L. William Pearce
Vice President724-682-5234
Fax: 724-643-8069July 8, 2005
L-05-112U. S. Nuclear Regulatory Commission
Attention: Document Control Desk
Washington, DC 20555-0001

**Subject: Beaver Valley Power Station, Unit Nos. 1 and 2
BV-1 Docket No. 50-334, License No. DPR-66
BV-2 Docket No. 50-412, License No. NPF-73
Responses to a Request for Additional Information in Support of License
Amendment Request Nos. 302 and 173**

Non-Proprietary responses to RAI dated May 5, 2005

Figure E.7-1
BVPS-1 1.5-Inch Break
Broken Loop Pump Suction Cross Over Leg Liquid Level

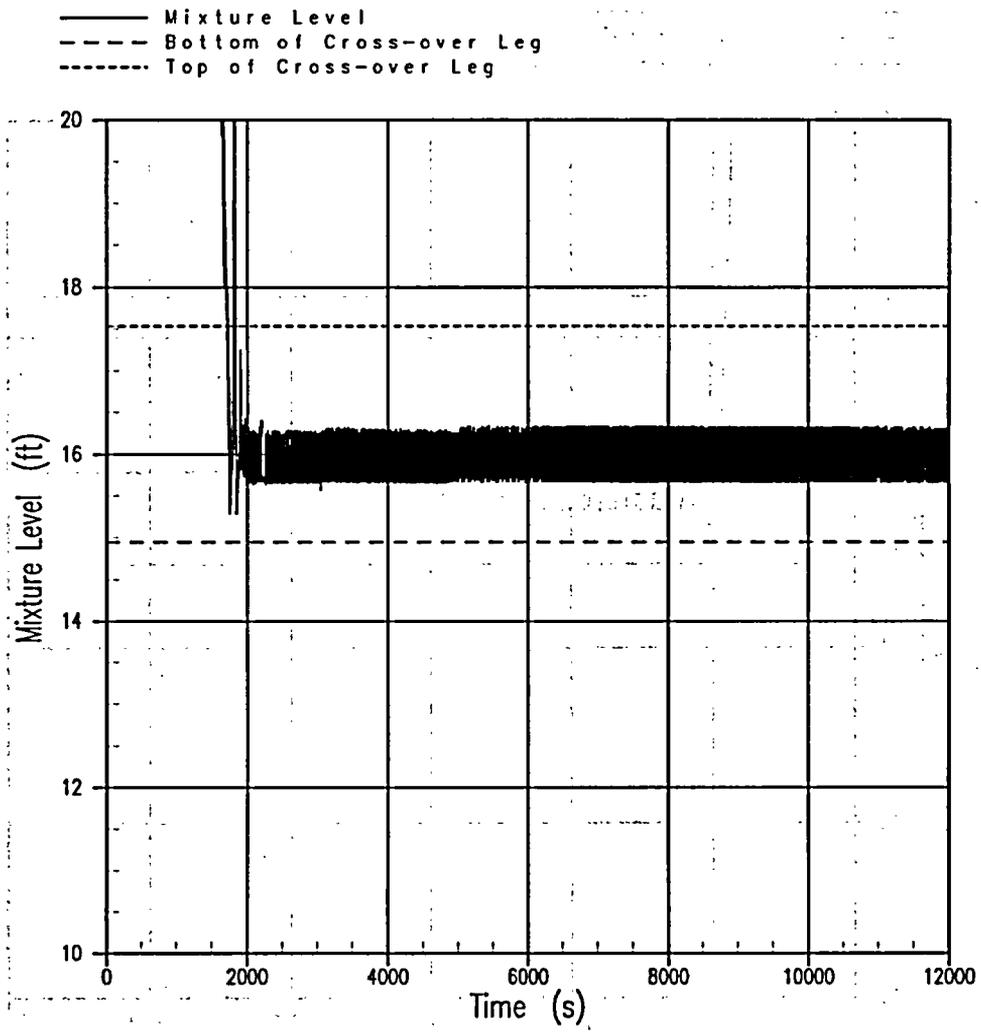
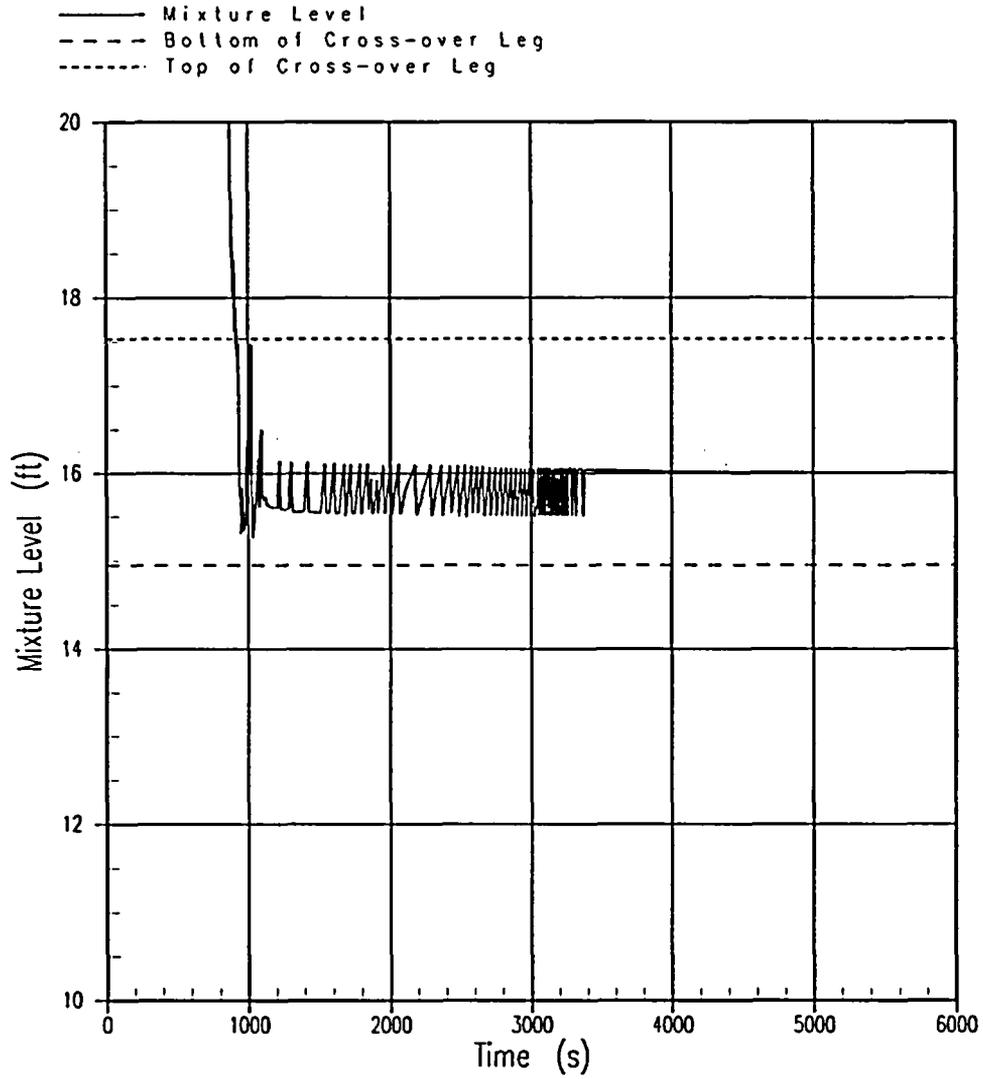
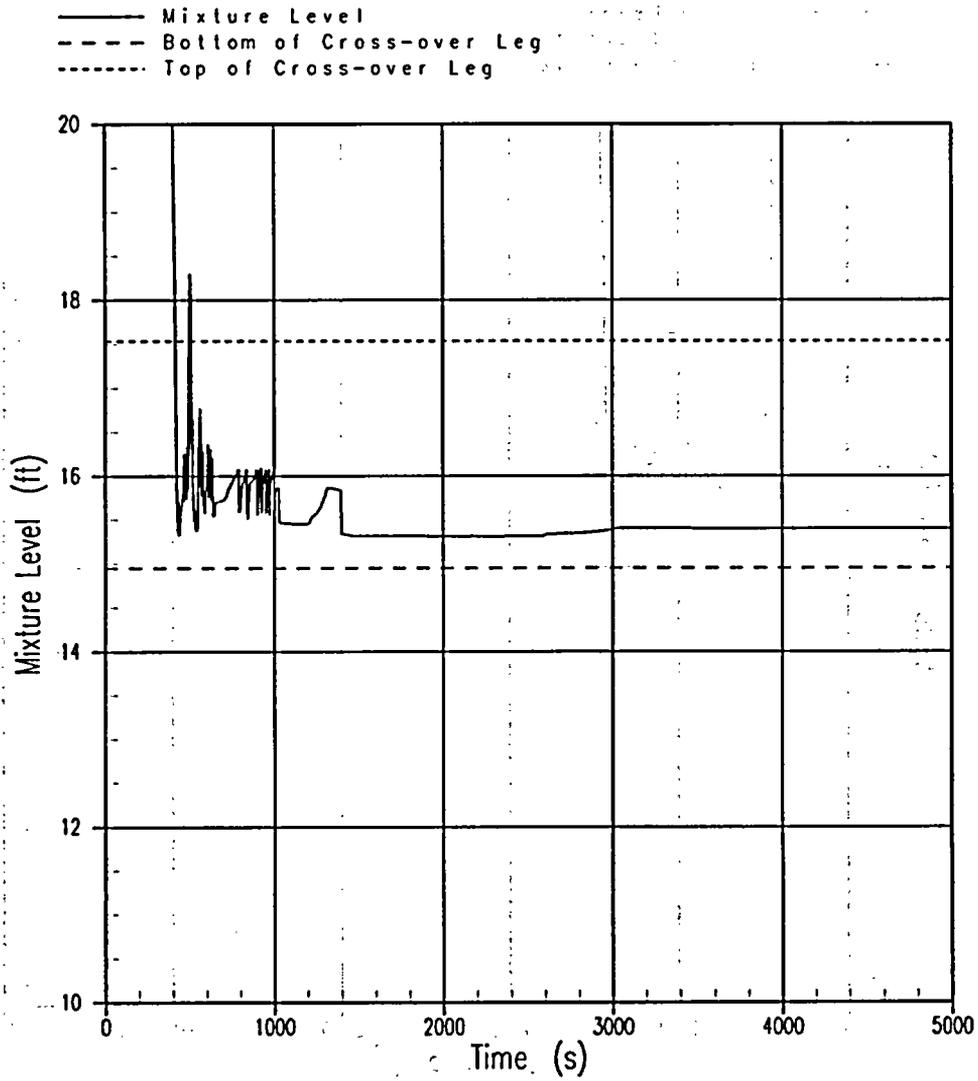
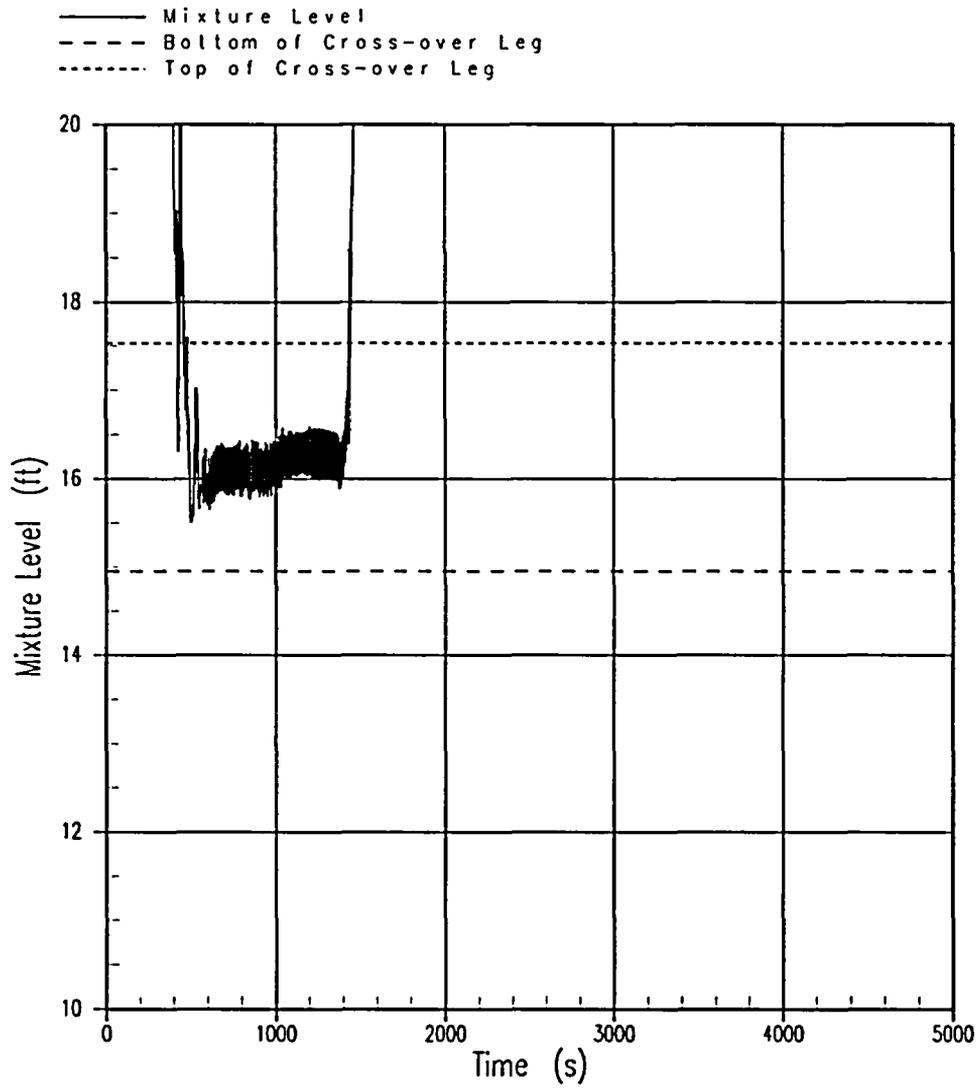
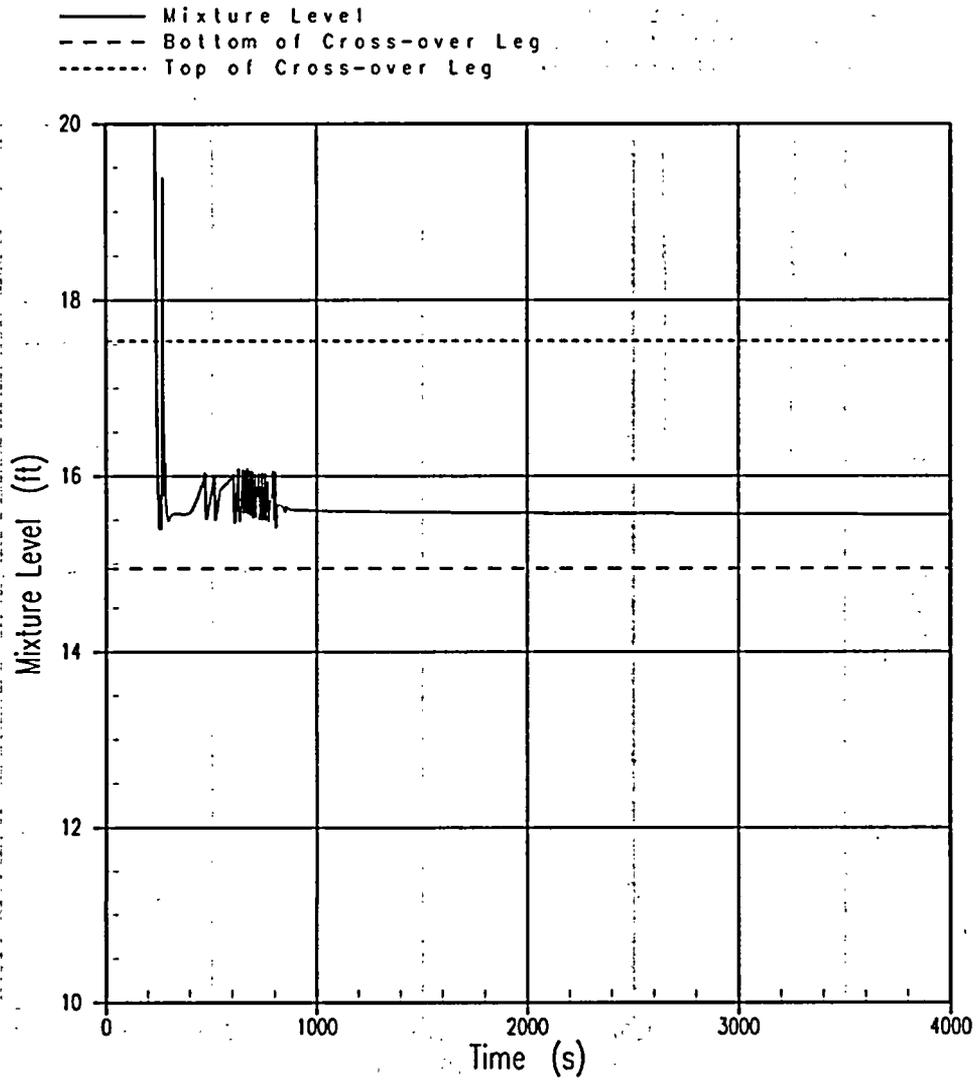
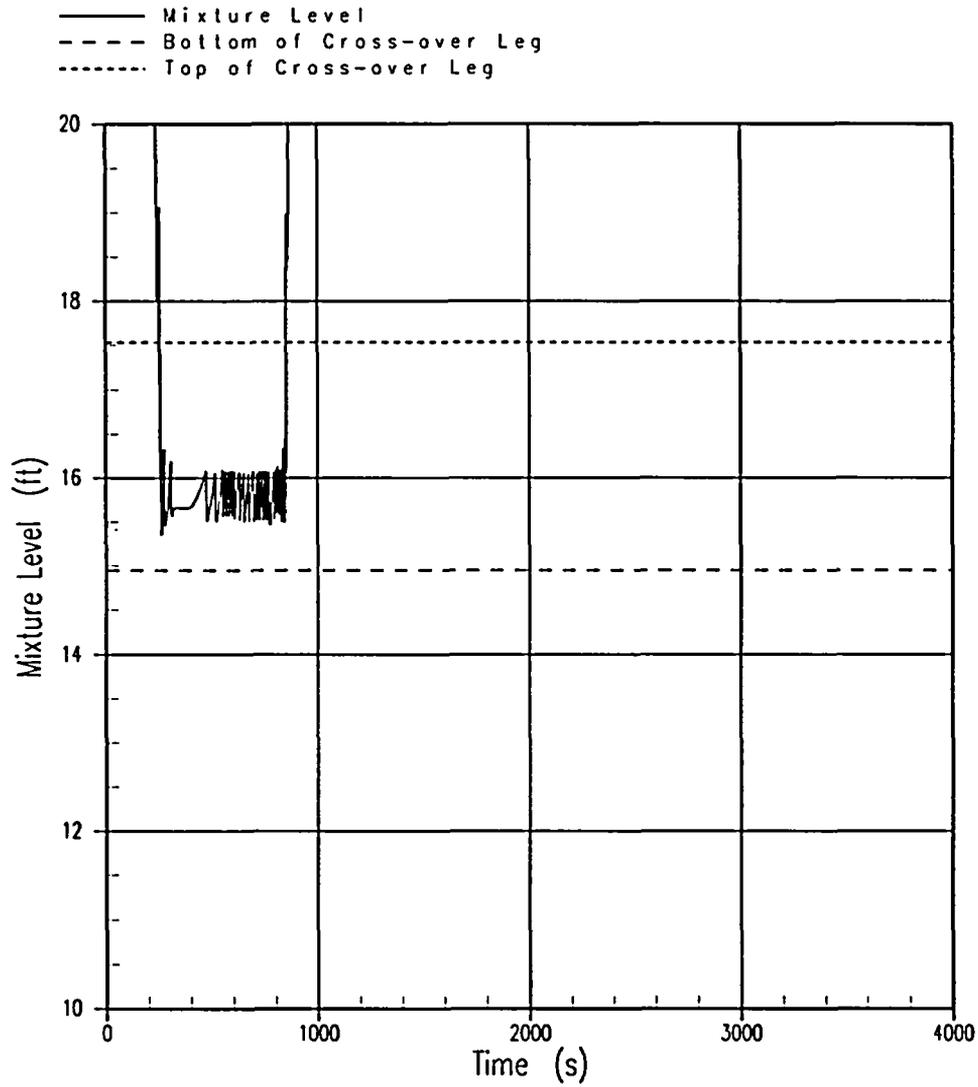
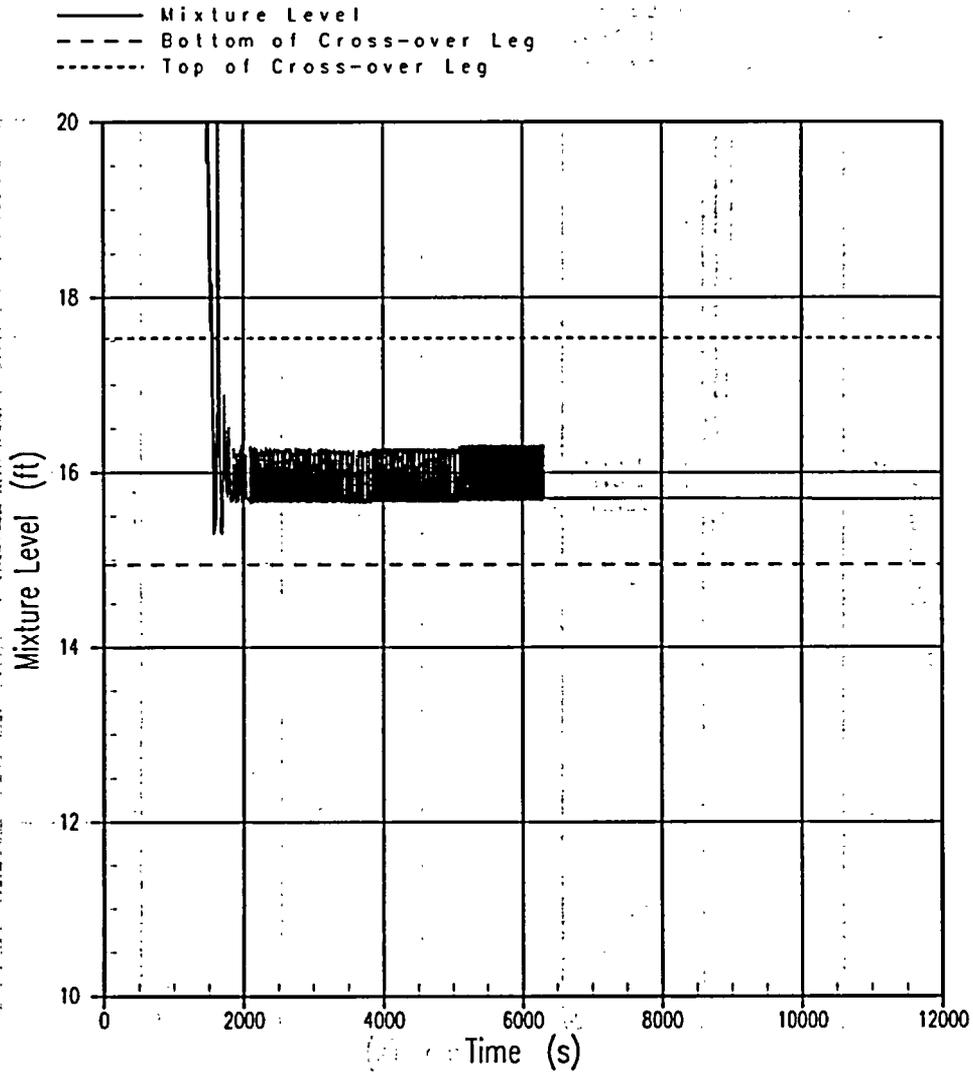
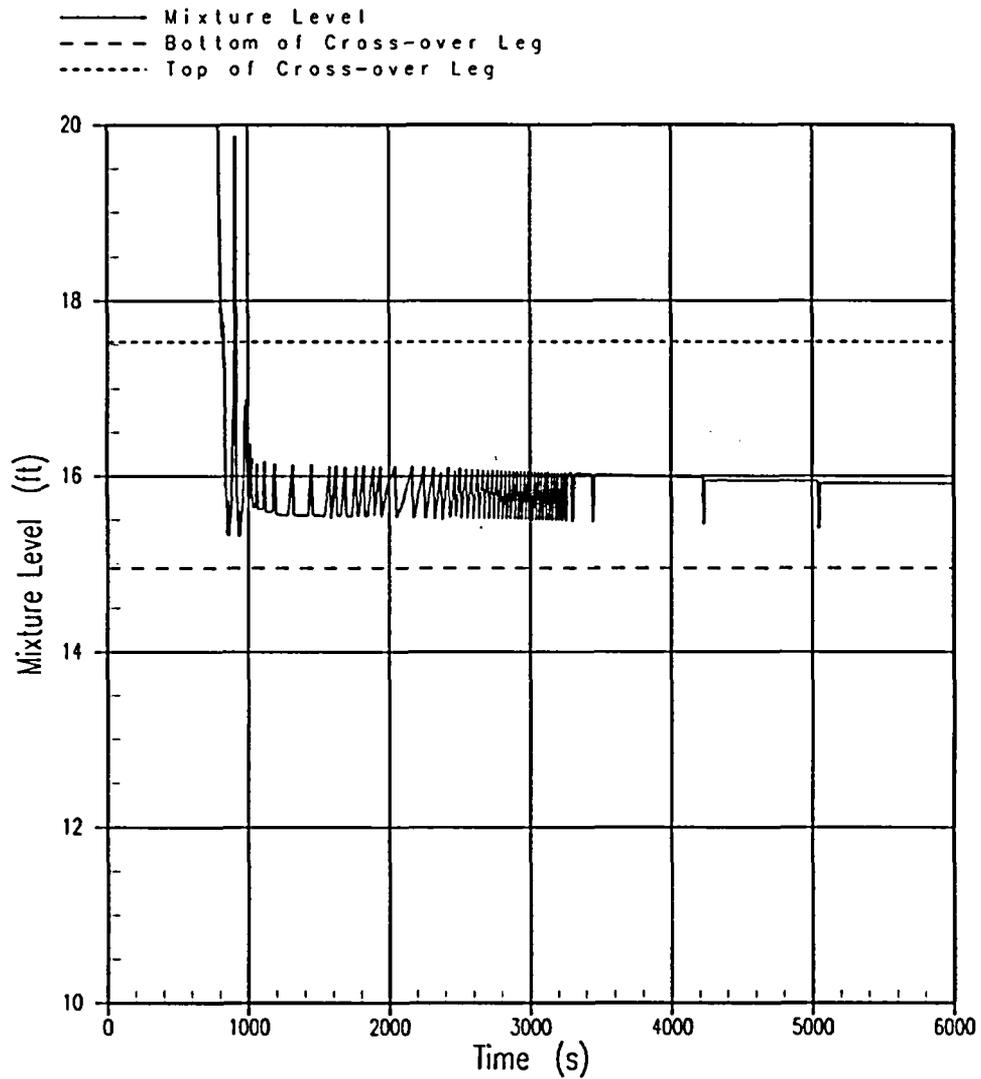
The reactor coolant pump (RCP) suction cross-over leg in the NOTRUMP-EM is modeled as [

]^{ac}
Figures E.7-1 through E.7-11 plots summarize the mixture level associated with the steam generator output plenum to horizontal cross-over leg piping with respect to time for BVPS-1 and 2.
